寄件者: Louis Tse [REDACTED]
寄件日期: 2026年02月04日星期三 18:11
收件者: tpbpd/PLAND
副本: Andrea Wing Yin YAN/PLAND; Ivan Sze Yuet FUNG/PLAND; Bon Tang; Matthew Ng;
Christian Chim; Danny Ng; Grace Wong
主旨: [FI] S.16 Application No. A/YL-KTN/1180 - FI to address departmental comments
附件: FI2 for A_YL-KTN_1180 (20260204).pdf
類別: Internet Email

2nd Further Information

Proposed Temporary Warehouse (Excluding Dangerous Goods Godown) with Ancillary Facilities and Associated Filling of Land and Pond for a Period of 3 Years in "Agriculture" Zone, Various Lots in D.D. 107 and Adjoining Government Land, Kam Tin, Yuen Long, N.T.

(S.16 Planning Application No. A/YL-KTN/1180)

Drawing No.	Stage	Rev.
W1010/116	P	A

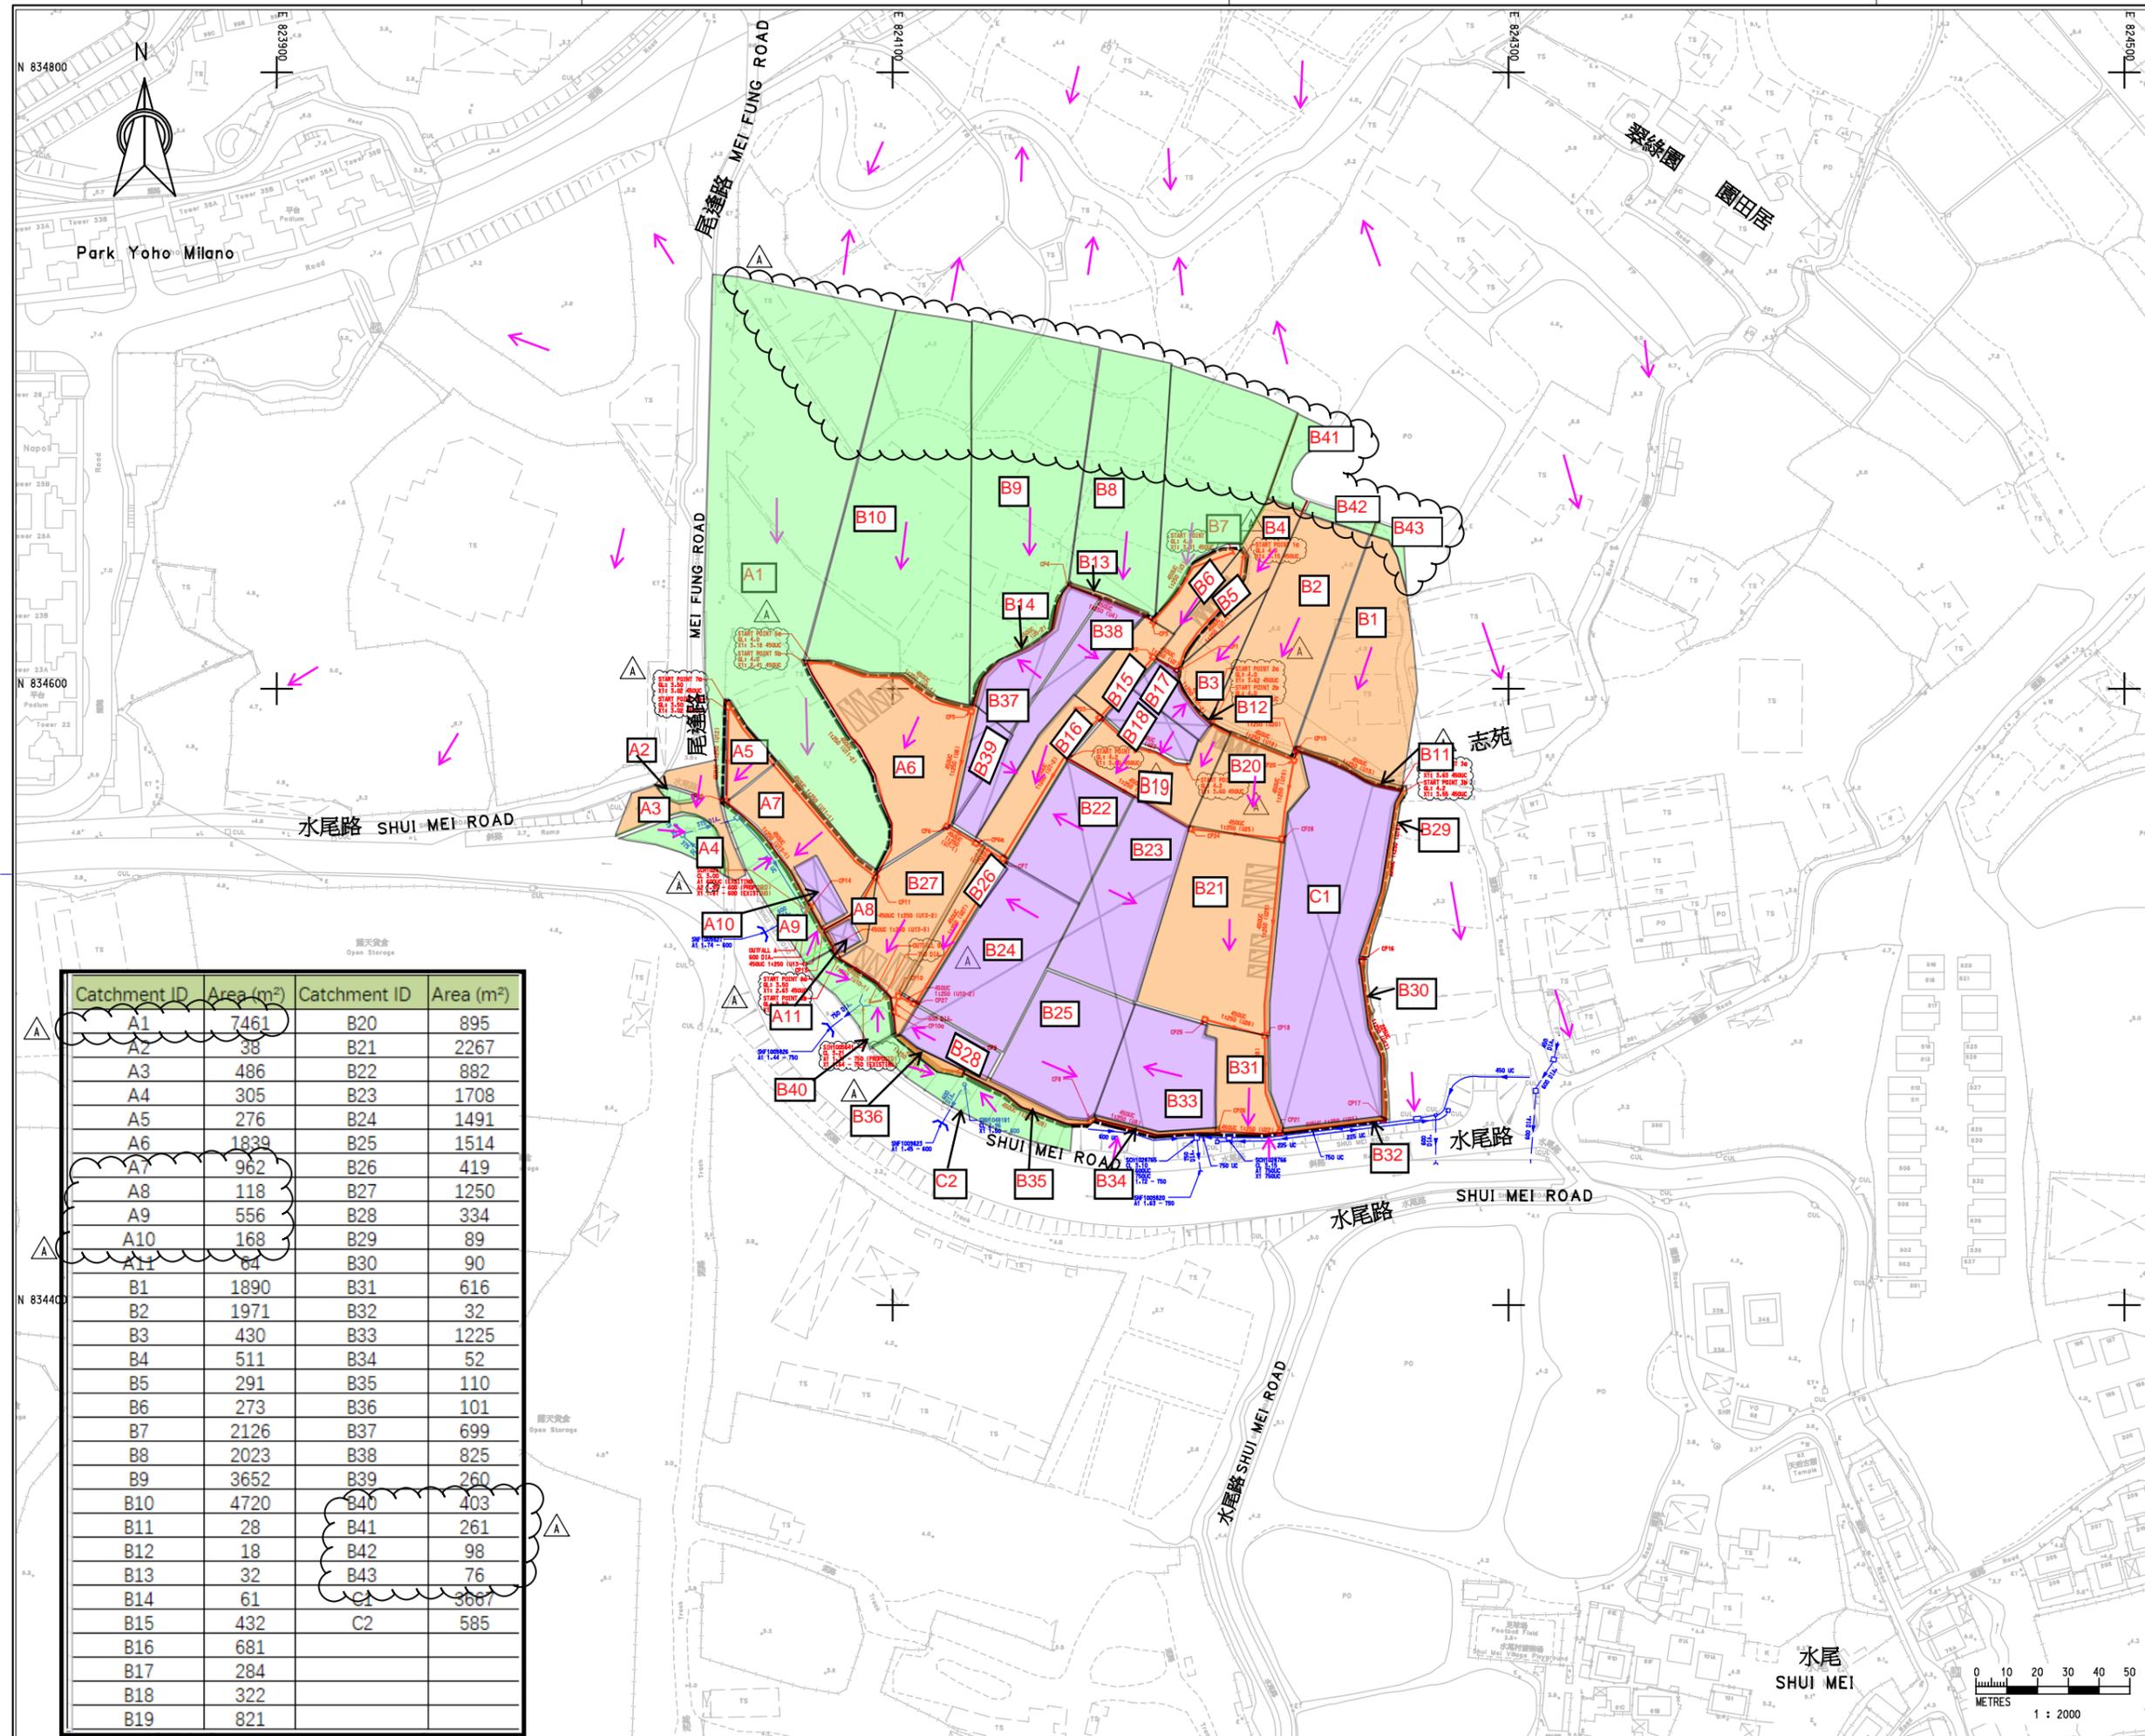
(A) Specific Comments		
(1)	<p>The ground to the north and northeast of the application site is generally higher. According to the topography around the subject site, external catchment area shall be greater than the one adopted in the submitted hydraulic calculation. The applicant should update hydraulic calculation.</p>	<p>A revised drainage impact assessment (DIA) is provided by the applicant to review the drainage arrangement for the proposed development (Annex III).</p> <p>We have further expanded the catchment area in this study to cope with the site at the north and northeast of the project site based on the available topographic information.</p> <p>The corresponding hydraulic calculation in Appendix B has been also updated based on this revised catchment area, which it is shown in the drawing nos. W1010/115 & 116.</p>

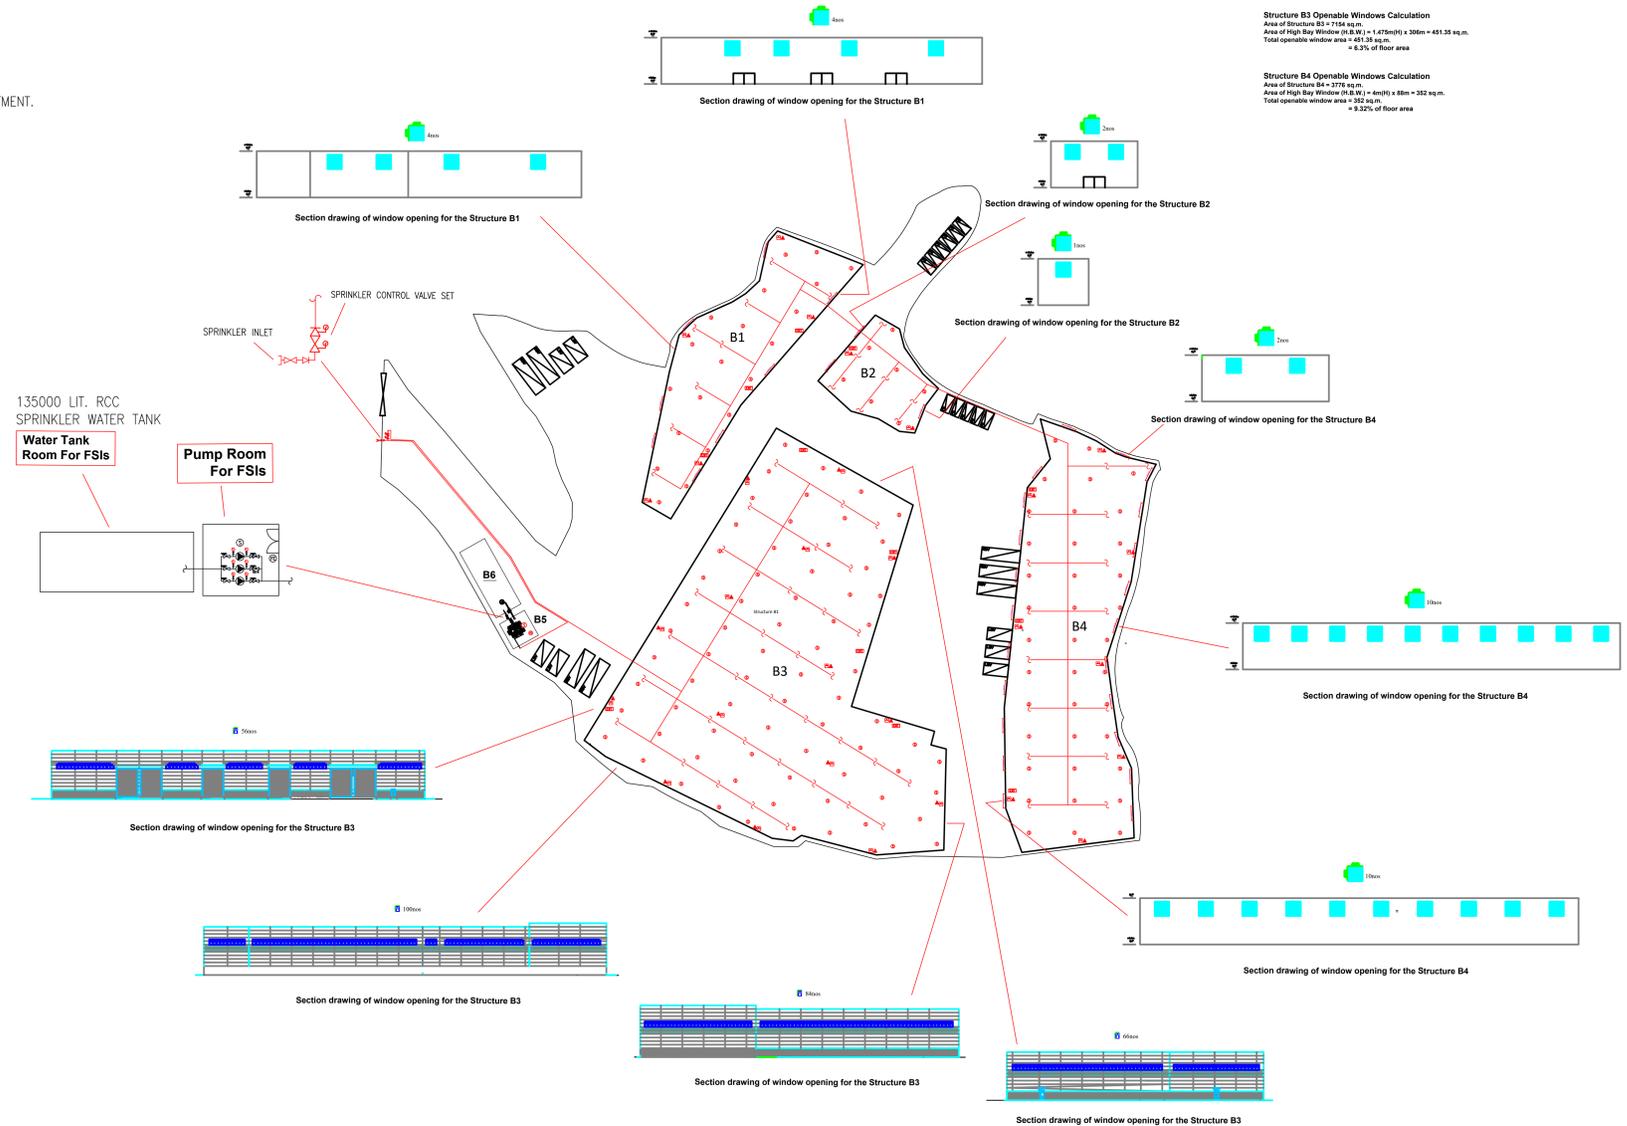
2. Comments of the Director of Fire Services (D of FS) (Contact Person: Mr. CHEUNG Wing-hei; Tel: 2733 7737)		
(1)	Sufficient number of wheeled type dry chemical fire extinguisher shall be provided so that a 20-35 kg wheeled type dry chemical fire extinguisher shall be provided in every 500 m ² on every floor of the premises and ensure that every part of the premises can be reached from a distance of not more than 30 m; and	Please refer to the revised fire service installations (FSIs) proposal (Annex IV). Sufficient number of wheeled type dry chemical fire extinguisher are provided.

(2)	For ordinary hazard group III, an automatic sprinkler system supplied by a 135,000 L water tank shall be provided.	An automatic sprinkler system supplied by a 135,000 L water tank is provided.
